GW - 28

**GENERAL
CORRESPONDENCE**

MINUTES

NAVAJO REFINERY COMMITMENTS FOR DISCHARGE PLAN
(Agreed to at OCD/Navajo Meeting 2/11/88)

LOCATIONS OF WELL POINTS

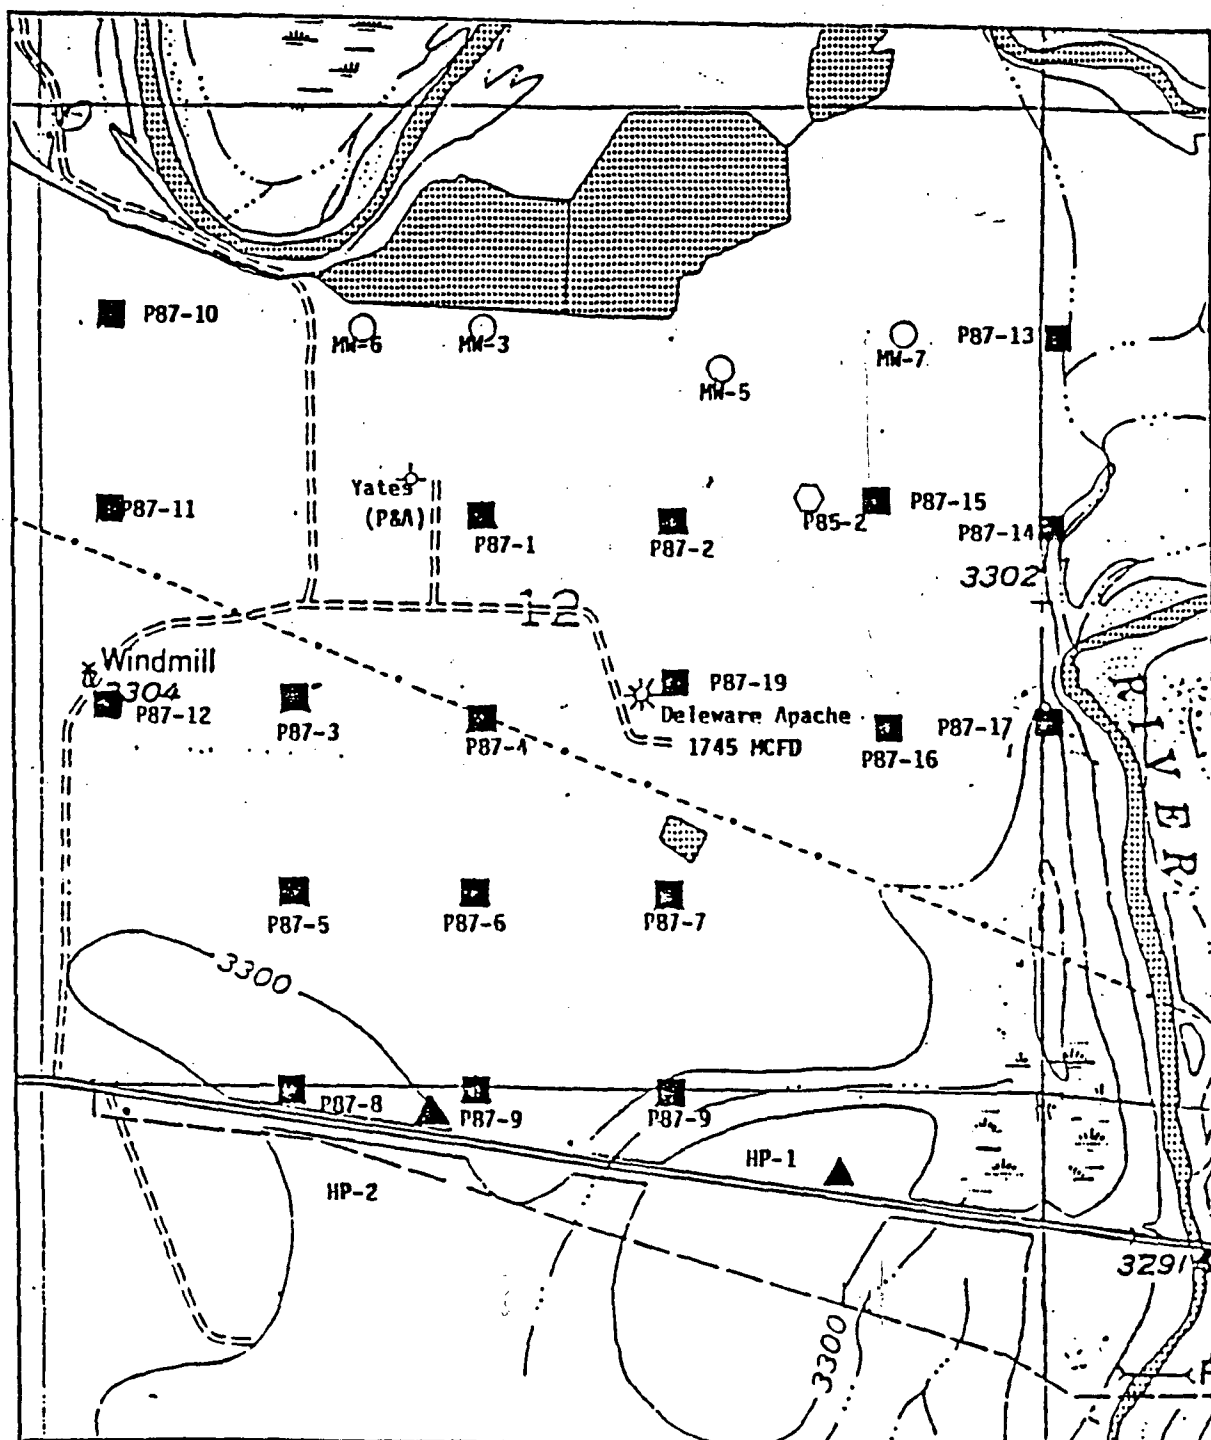
1. A well is being required by OCD to be located at the southern boundary of the proposed 80-acres to be acquired by Navajo. The east-west location is to be determined after submittal of water levels in several of the well points installed by Navajo in the spring of 1987. These points are not useful for water quality monitoring but are excellent for use as piezometers to determine flow direction from the ponds. If they can be located, stabilized and surveyed they can provide much meaningful data with little additional expense. The points necessary to establish water levels for a location for a new monitor well are:

Provide elevation and water levels for these points. In addition please provide water levels (and elevation and location data if not previously

supplied and/or verified) for MW-3, 4, 5, 6, and 7. All water levels for well points and monitoring wells should be taken the same day if possible.

Figure 6-1
TYPICAL MONITOR WELL DESIGN

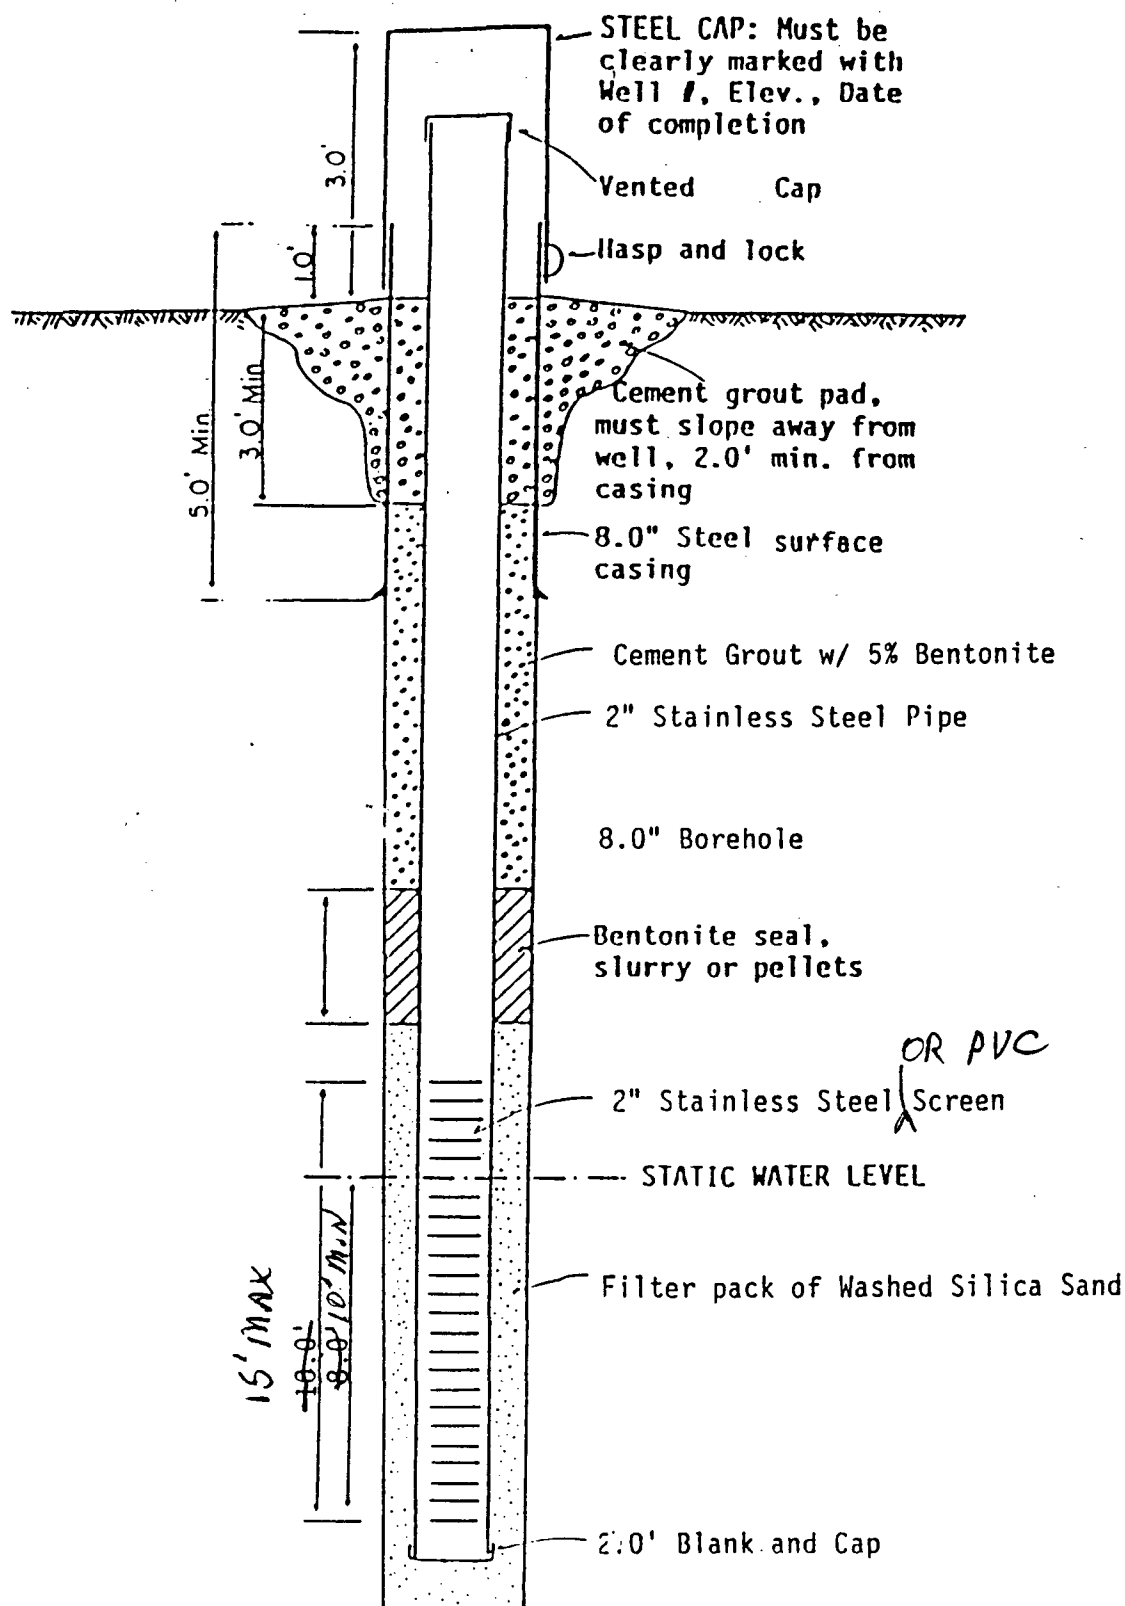
3. Attached is a typical monitor well of the design used in the earlier RCRA wells that you can use as a guide. Our only requirements are that you have a minimum of ten (10) feet of saturated thickness but that the maximum saturation does not exceed fifteen (15) feet, that the top of the screen not be submerged, that the filter pack top be placed about 12 inches above the top of the screens (to prevent bentonite migration) and that adequate surface casing and cement be placed to stabilize and seal the well. PVC may be used instead of stainless steel for the well itself.
